RIDGWAY PLANNING COMMISSION

REGULAR MEETING AGENDA

Tuesday, October 26, 2021

To: Town of Ridgway Planning Commission
Cc: Preston Neill, *Ridgway Town Manager*
From: TJ Dlubac, AICP, *Community Planning Strategies, Contracted Town Planner*
Date: October 21, 2021
Subject: McIsaac Subdivision Planned Unit Development Preliminary Plan and Plat for October 26th PC Meeting

UTILITY PLAN
C5.0

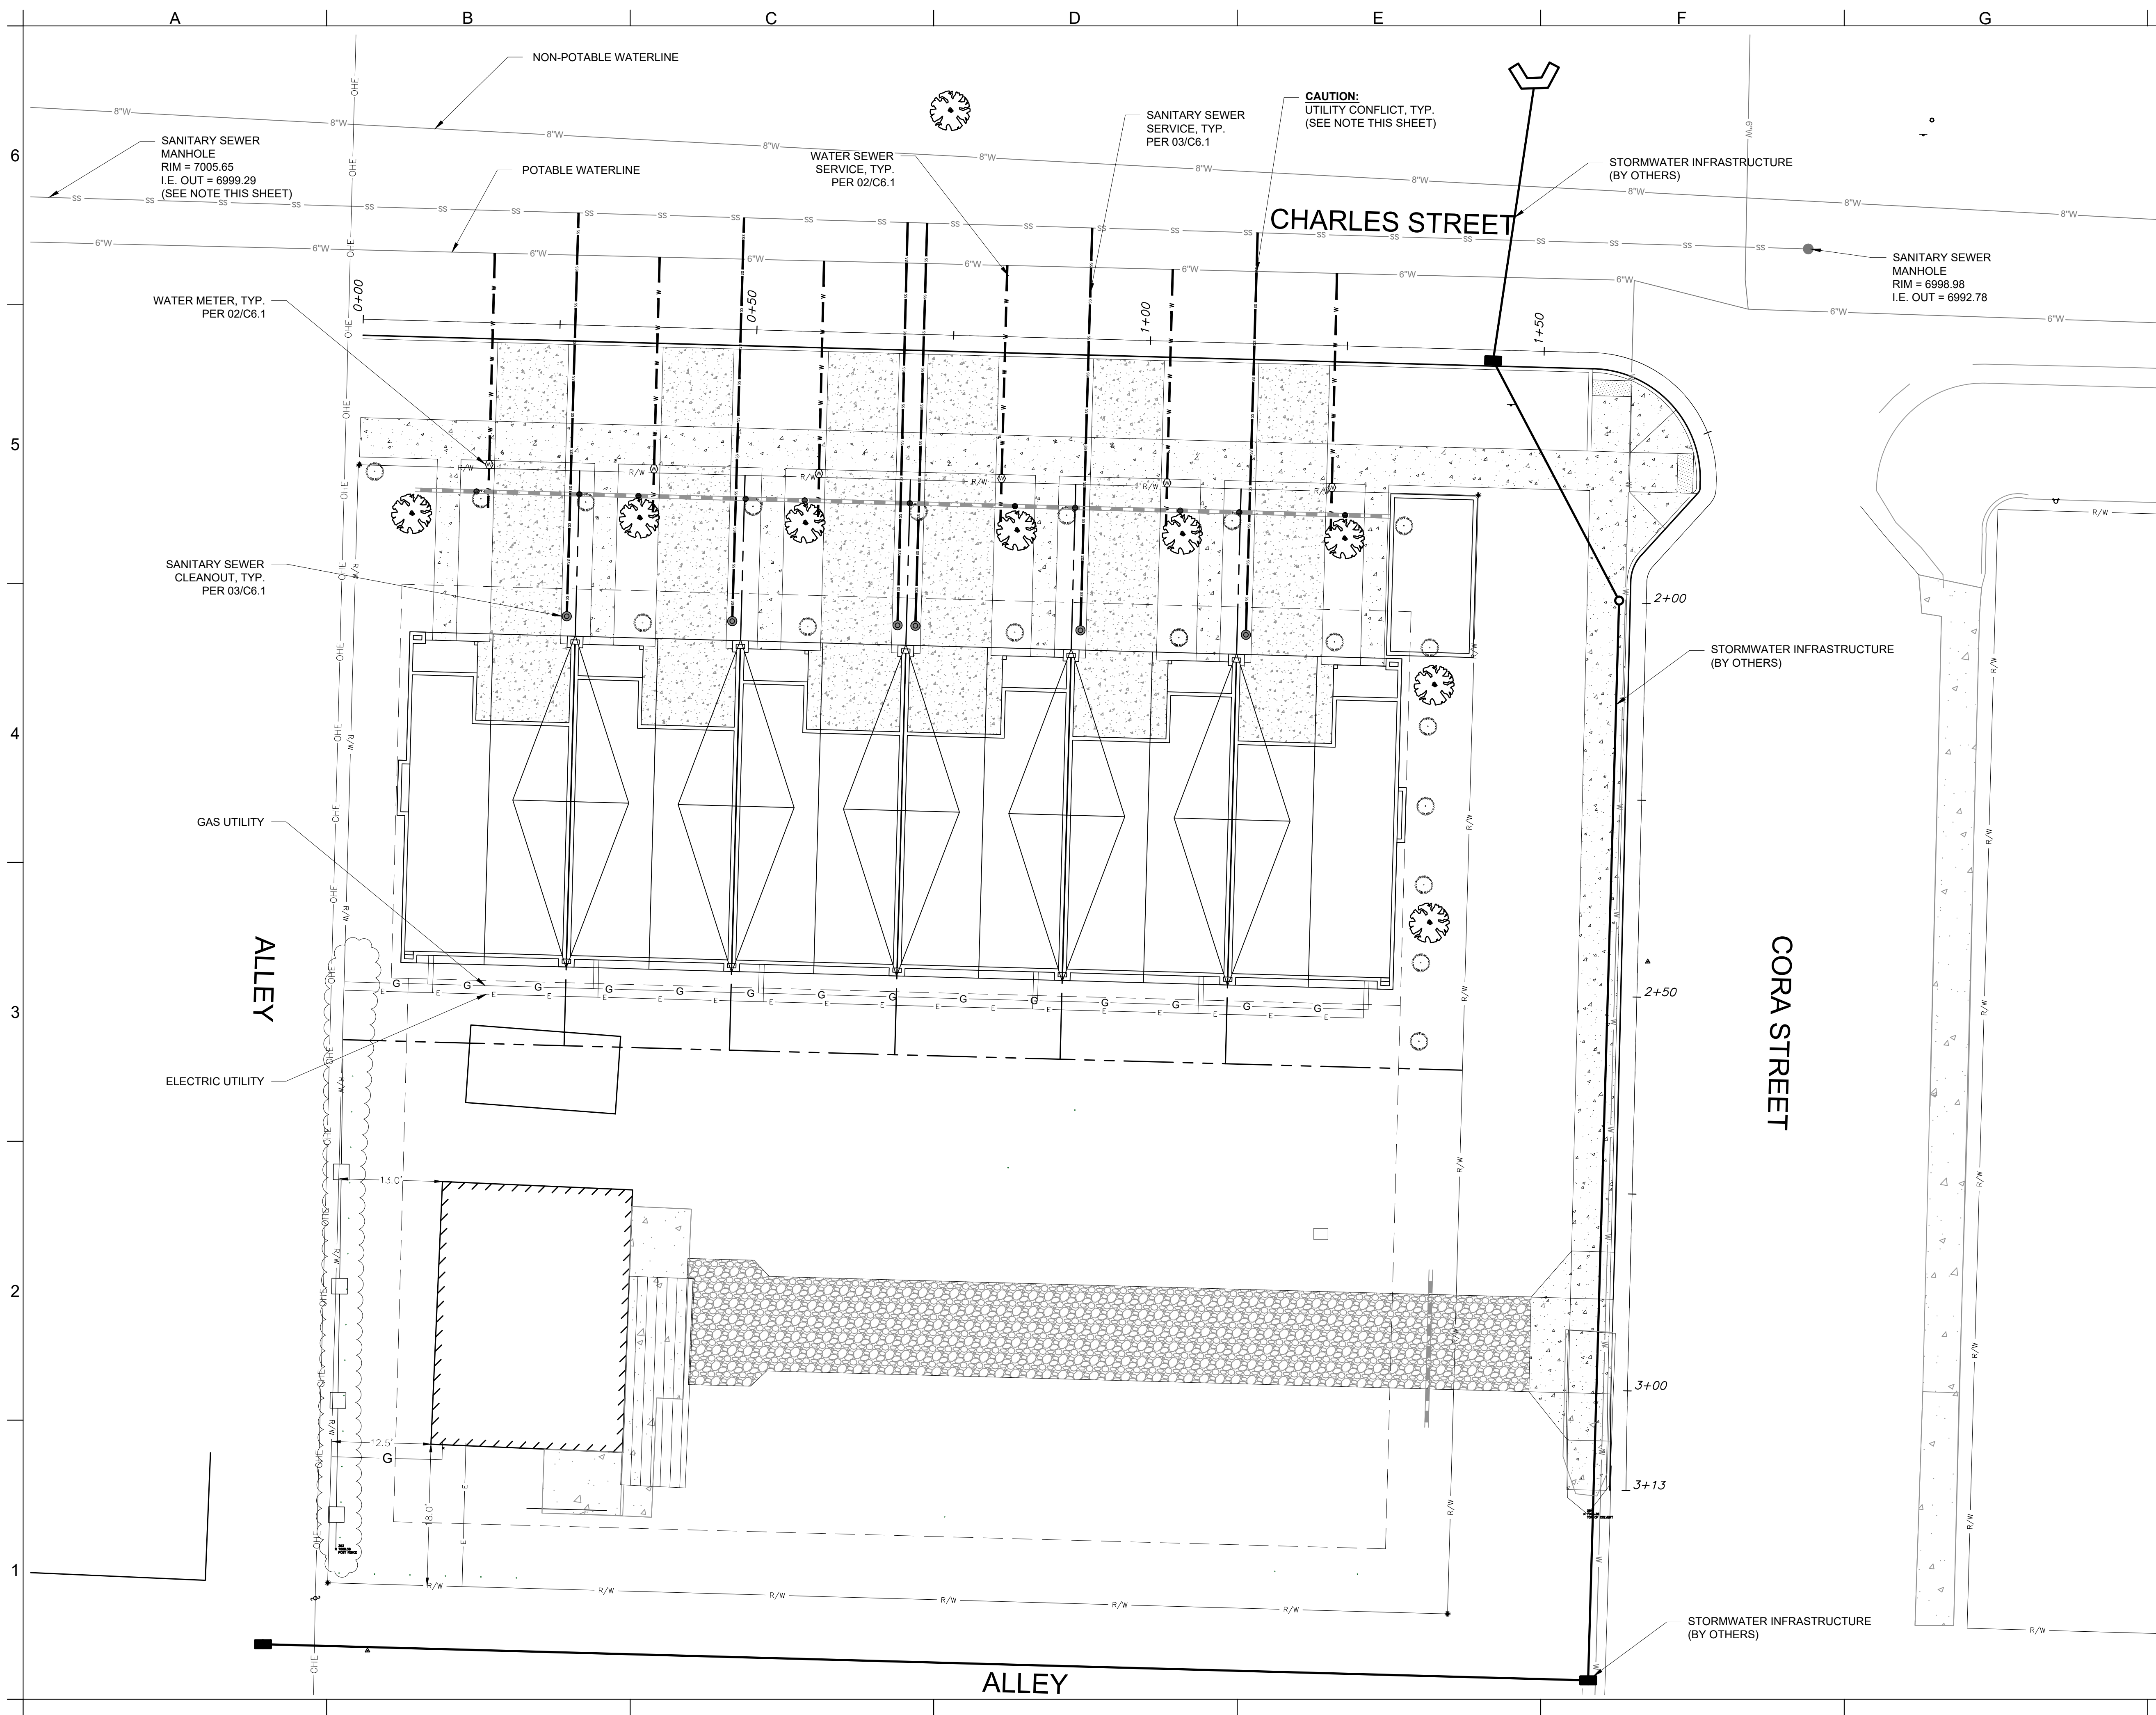
C5.0	Utility		Does the existing water cross the existing sewer? Will that impact the installation of the sewer service shown to be at the cross over point?	Have changed the existing utility layout and that eliminated the crossing		
C5.0	Utility		Add the manhole at Charles and Cora. You will need to get invert elevations on this manhole and the one upstream to determine the tap elevations and then check how the sewer taps will work crossing the water lines	Manhole added graphically. Did not find the invert or rim or calcs for how the sewer taps cross the water main.	Rim and invert elevation have been added. Note has been added to encase sanitary sewer services per Town standards.

Pg	Sht Name	Utility	Town Comments - April XX, 2021	Town Comments 6/24/21	Design Engineer Responses 8/16/21	
C5.0	Utility		We recommend against running a water service under a line a trees	Still showing the water services terminating at the line of trees	According to Matt McIsaac the landscaping requirement are changing due to constant shortage of water. Owner/Engineer shall coordinate with town prior to construction per the updated landscape requirements.	
C5.0	Utility		There are two sets of stationing. What are each for?	Stationing is gone. Plans need to show how to locate the services on the ground	Stationing was incorrectly removed. Stationing is now showing.	
C5.0	Utility			There is a note on this sheet that says <i>location of underground utilities... are not final. Coordination with utility owners shall determine the final location.</i> Plans submitted for preliminary plat approval need to final. Coordination must already be completed and the outcome reflected on the plans they want the town to approve for preliminary plat approval and construction.	Note has been updated to state Ridgway's encasement requirements for sanitary sewer lines crossing over and under water mains or services. Potable waterline is 5.5' below grade. Sanitary Sewer is 5.83 feet below grade at the West manhole and 5.75' below grade at the manhole located at the intersection of Charles and Cora.

C5.0	Utility	Sewer	How does one locate the taps on the ground? Perhaps add stationing from the D/S manhole	Not addressed	Stationing has been added for referencing locations per the proposed curb & gutter.	I did not see stationing for utility service lines. See comment below about stationing						
C5.0	Utility					Utility lines are supposed to be color coded. If it's a hassle, we can let it go for this, but please do it on future projects						
			The service lines should have a cleanout at the end per the service detail	Not addressed	Cleanouts have been added to end of line, please see sheet C5.0. Extend service lines to show cleanout with 5' foundation to ensure cleanout functions for most of the length installed.	OK						
C5.0	Utility	Sewer	Why are the sewer services on the west (U/S) side of the easterly 3 lots	Not addressed	????	The sewer services are shown on the low side of the lot on 3 lots and on the upstream side of the other 3 lots. Why are the latter on the uphill side of the lot

C5.0	Utility	Irrigation	Was irrigation required from Sketch plan approval?	Not addressed	Irrigation requirement TBD							
C5.0	Utility		Label which is potable and which is non potable	Not addressed	Waterlines have been labeled in accordingly	found a leader that distinguishes. Having a different line type or color coding would make it clearer especially if someone is looking on a small screen.						
C5.0	Utility		Add the manhole at Charles and Cora. You will need to get invert elevattions on this manhole and the one upstream to determine the tap elevations and then check how the sewer taps will work crossing the water lines	Manhole added graphically. Did not find the invert or rim or calcs for how the sewer taps cross the water main.	Rim and invert elevation have been added. Note has been added to encase sanitary sewer services per Town standards.	As noted above the calcs for how the sewer services cross the water should be shown. Note that the water main near the existing culvert has about 4.5 ft of cover. Please confirm that if the water has a 4.5' bury, a 4" encased sewer service above the water main can get to each of the buildings at a depth that meets the plumbing code and serves the building. Note there needs to be 3" between the two pipes

Town Comments - April XX, 2021			Developer Engineer Response 8/16/21	Town Comments 9/14/21						
Pg	Sht Name	Utility	Town Comments 6/24/21							
C5.0	Utility		There are two sets of stationing. What are each for?	Stationing is gone. Plans need to show how to locate the services on the ground	Stationing was incorrectly removed. Stationing is now showing.	There is stationing for the gutter, but not to locate the services. Typically utility lines are stationed from manholes or intersections. If you want to use the gutter stationing for the 12 services lines, we will allow it, but the stations for the water and sewer services needs to be				
C5.0	Utility			There is a note on this sheet that says <i>location of underground utilities... are not final. Coordination with utility owners shall determine the final location.</i> Plans submitted for preliminary plat approval need to final. Coordination must already be completed and the outcome reflected on the plans they want the town to approve for preliminary plat approval and construction.	Note has been updated to state Ridgway's encasement requirements for sanitary sewer lines crossing over and under water mains or services. Potable waterline is 5.5' below grade. Sanitary Sewer is 5.83 feet below grade at the West manhole and 5.75' below grade at the manhole located at the intersection of Charles and Cora.	What is the basis for concluding potable line is 5.5' below grade. Is that cover or invert. As noted above cover was about 4.5' where the Town potholed a couple of months ago. The manhole dips show 6.2' and 6.36' from rim to invert. Rims are at least several inches below grade. Are there ground elevations at the manholes? The sewer in Charles is listed as 6" which has a minimum wall thickness of 0.2" which would make the top of pipe about 0.52' higher than the invert. The 5.8' below grade looks to be based on rim elevation and not accounting for fill over the manhole covers. If the invert of the sewer is around 5.8' the bottom of the service would typically be less than 5' which could cause conflict with the water. Unless the developer is proposing to re-lay the water line for a few hundred feet, the sewer services will likely need to go over the water

PRELIMINARY PLAT
LOTS 1-7, RIDGSIX TOWNHOMES,
TOWN OF RIDGWAY,
SECTION 21, T44N, R10W, N.M.P.M.,
OURAY COUNTY, COLORADO.

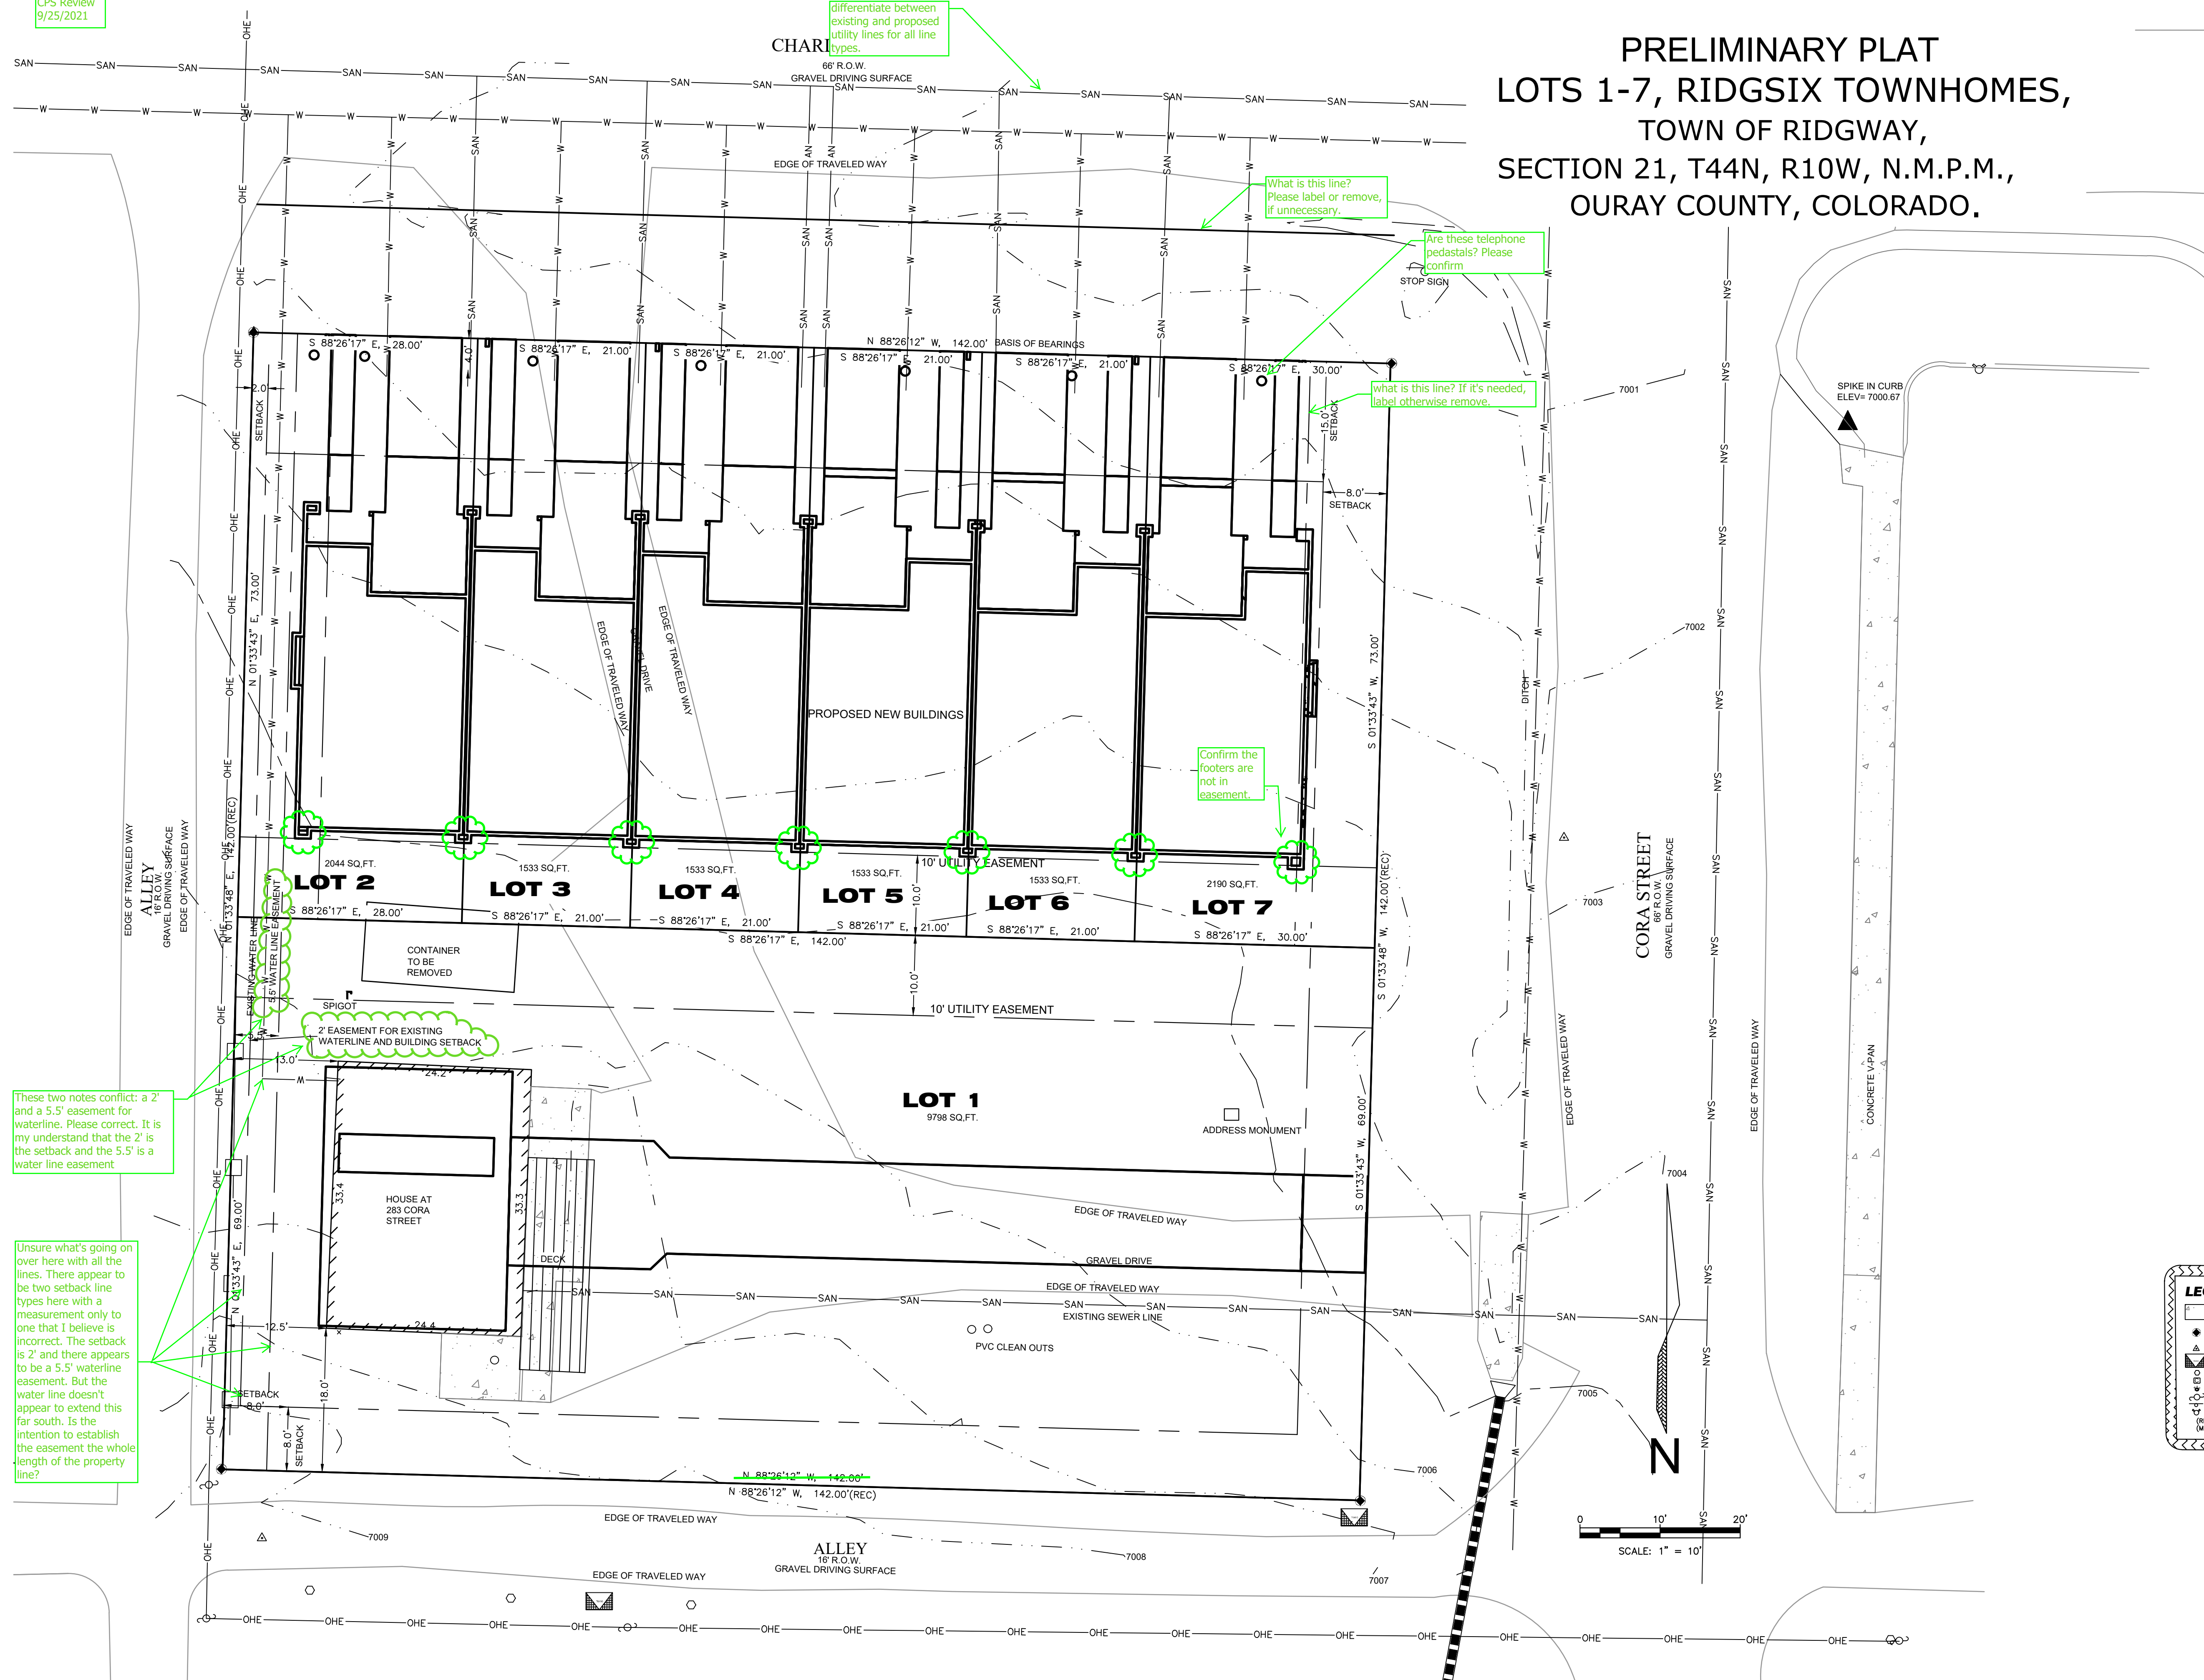
CPS Response: Not all edits were addressed. Please address the following comments related to various certificate blocks on Sheet 1 of the Preliminary Plat:

Standard	Required	Lot 2	Lot 3	Lot 4	Lot 5	Lot 6	Lot 7
Width	70'	28'	21'	21'	21'	21'	30
Size	10,000	2,044sf	1,533sf	1,533sf	1,533sf	1,533sf	2,190sf
Lot Coverage	50%	Not identified. Please add to Summary Table on Sheet 1 of plat. Include building footprints, driveways, and walkways in this calculation.

33. Remove Notes 2, 4, and 6 from Sheet 1 of the Preliminary Plat. They should be relocated to the PUD on Sheet SP1 (See new comment #37 for PUD notes).
